ICHD - ENVIRONMENTAL HEALTH DIVISION

SEPTIC: IMPROVEMENT PERMIT / AUTHORIZATION TO CONSTRUCT / OPERATION PERMIT / EXISTING SYSTEM

TITLE: FRANKLIN

FOR: BRIAN & KRISTIN TRAVIS

FIRST FLOOR PLAN

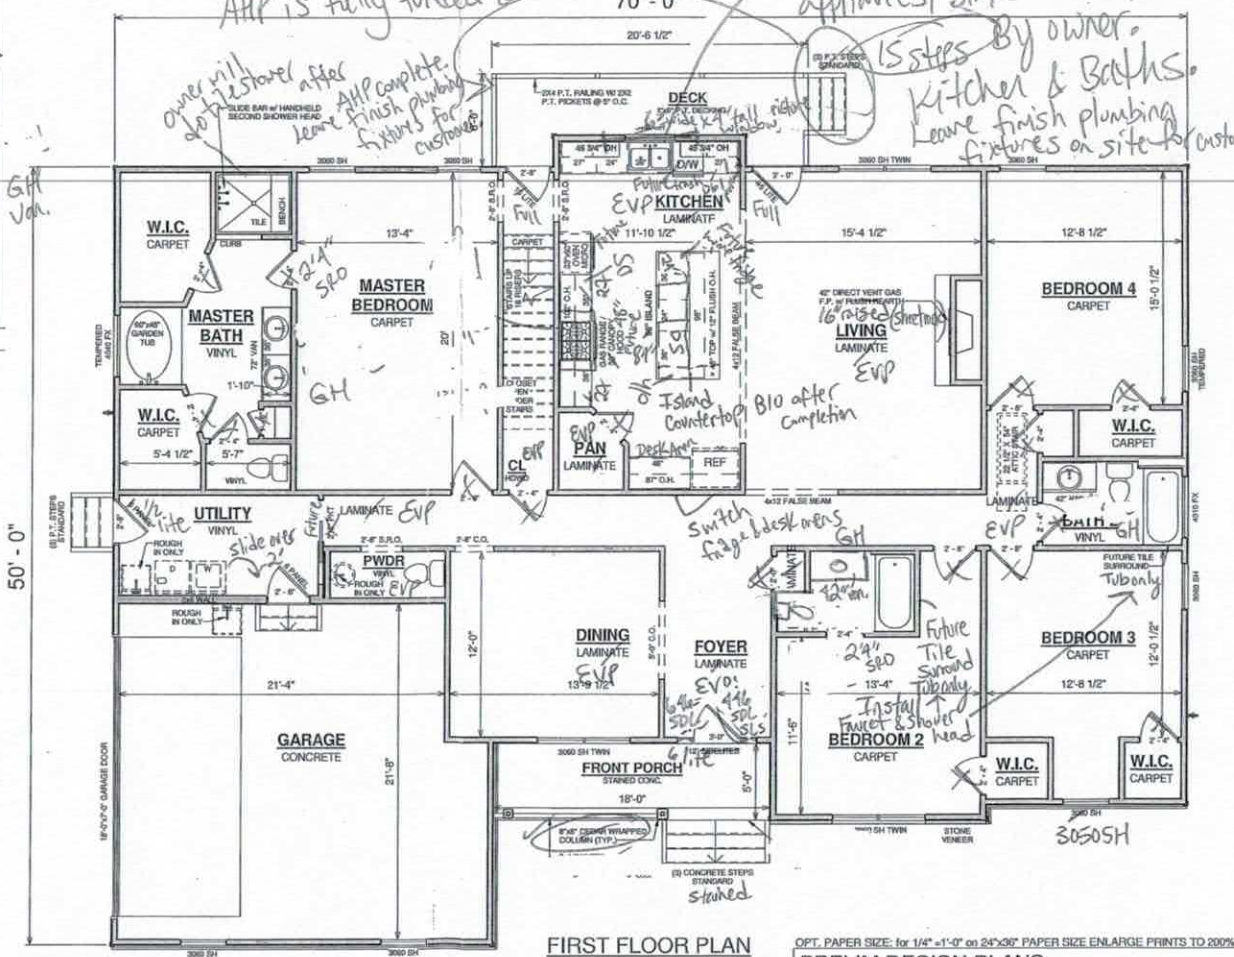
All int trim & int doors will be complete after AHP is fully forted & complete.

All cabs, countertops, appliances, sinks are fixture 15 steps By owner. Kitchen & Baths. Leave finish plumbing fixtures on site for custome

owner will do the shower after AHP complete. Leave finish plumbing fixtures for customer

All doors being deleted sheetrock to edge.

- ~~GRANITE KITCHEN COUNTERTOPS w/ 4" GRANITE BACKSPLASH AND UNDERMOUNT SINK~~ Delete
- ~~CULTURED MARBLE COUNTERTOPS IN ALL BATHS~~ Delete
- SMOOTH CEILINGS THROUGHOUT
- BATHROOM MIRRORS NOT INCLUDED
- CLOSET SHELVING NOT INCLUDED
- ~~5'x4' TILE SHOWER w/ 3' RETURN WALL, BENCH SEAT, AND SLIDE BAR HANDHELD SECOND SHOWER HEAD w/ CONTROLS - IN MASTER BATH~~ Delete
- CONCRETE FRONT PORCH TO BE COLOR STAINED w/ CLEAR SEALER

ELECTRICAL PLAN

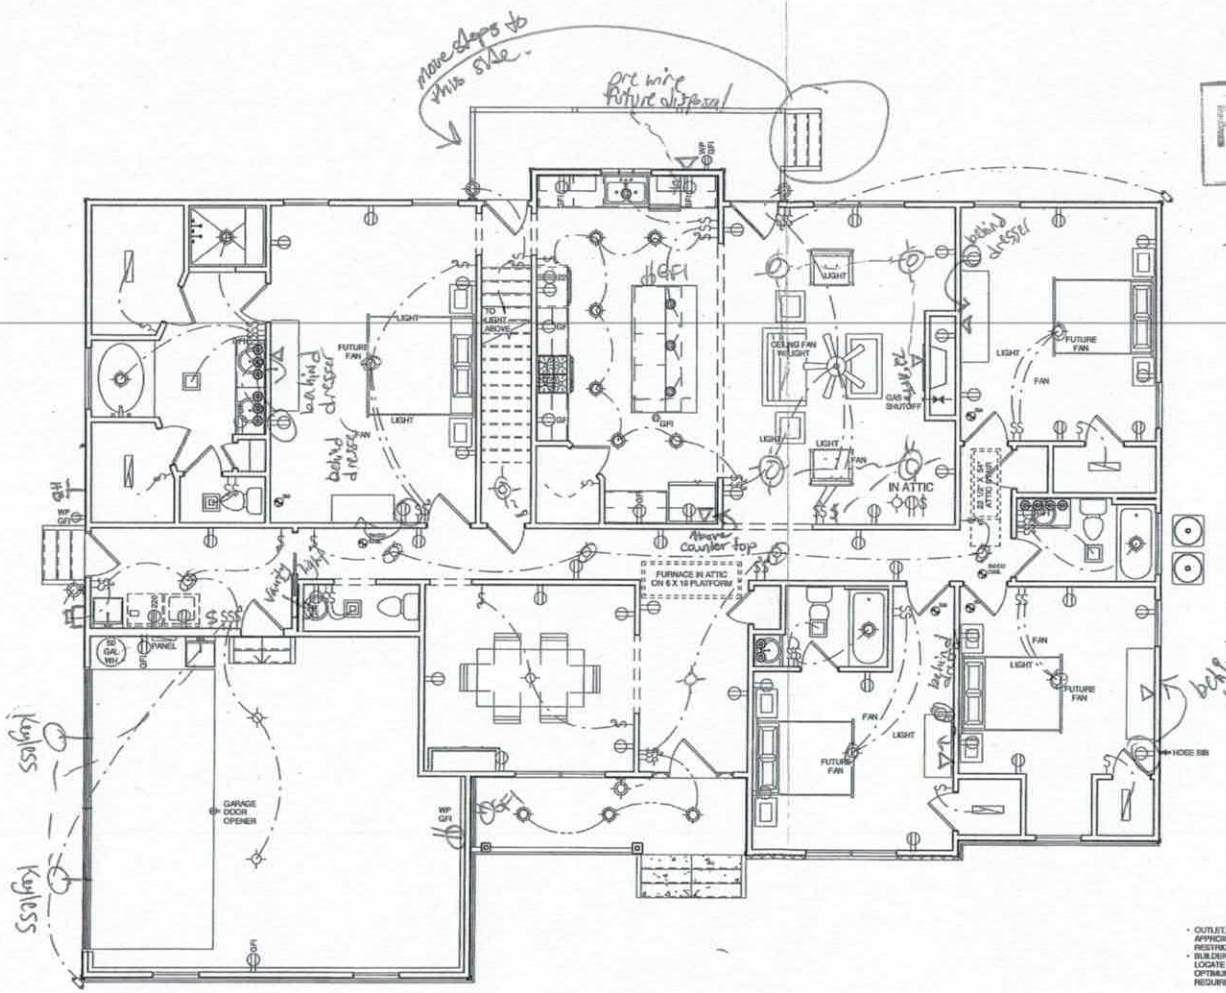
-PT in crawl

- Make all flush mount lights recessed lights.

- Make note to keep outlet behind dressers in bedrooms on rendering.
